Access Compliance Report

# Public Rights-of-Way
(Curb Ramps)

Intersection ID: 13683	Main Street: ELIZABETH_AV	Cross Street: CHARLOTTETOWNE_AV	Location:	N
ADA ID: 6B05B1171938	Ramp Type: Perp	Initial Pass/Fail: Fail	Overall Compliance: No	Severity Score: 10

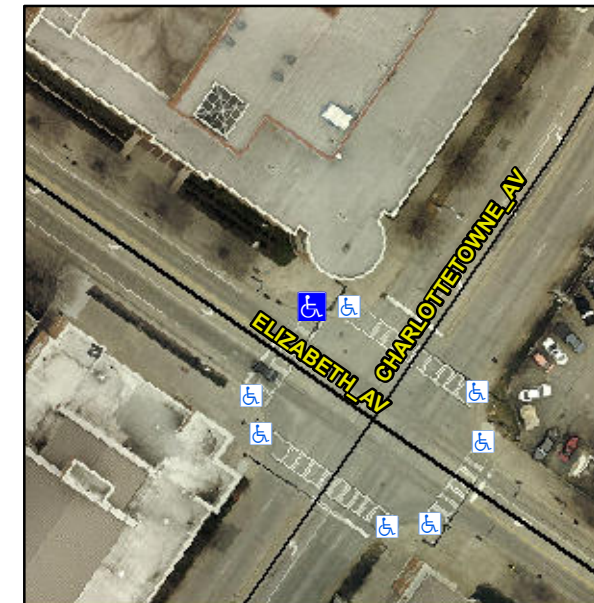
Not Found, R304.5.1

Compliance	Description	Data	Compliance	Description	Data
N/A	Ramp Length (in)	84.0	Yes	Ramp Slope (%)	7.1
No	Ramp Width (in)	46.5	Yes	Ramp XSlope (%)	2.3
N/A	Flare Type LT	N/A	N/A	Flare Type RT	N/A
N/A	Flare Slope LT (%)	N/A	N/A	Flare Slope RT (%)	N/A
N/A	Flare Traversable LT?	N/A	N/A	Flare Traversable RT?	N/A
N/A	Landing Length (in)	N/A	N/A	DWS Provided?	N/A
N/A	Landing Width (in)	N/A	N/A	DWS Contrast?	N/A
N/A	Landing Slope (%)	N/A	N/A	DWS Length (in)	N/A
N/A	Landing X Slope (%)	N/A	N/A	DWS Full Width?	N/A
N/A	Landing Curb? (Y/N)	N/A	N/A	DWS Offset (in)	N/A
N/A	Shared Landing?	N/A			
N/A	Gutter Ponding?	N/A	N/A	Gutter Slope (%)	N/A
N/A	Gutter Lip Ht (in)	N/A	N/A	Gutter X Slope (%)	N/A
N/A	Painted X Walk1?	Yes	N/A	Painted X Walk2?	N/A
	X Walk 1 Direction	To SW		X Walk 2 Direction	N/A
N/A	X Walk 1 Width (in)	106.0	N/A	X Walk 2 Width (in)	N/A
	X Walk 1 Slope (%)	0.2		X Walk 2 Slope (%)	N/A
	X Walk 1 X Slope (%)	2.4		X Walk 2 X Slope (%)	N/A

Remove & Replace Entire Ramp.
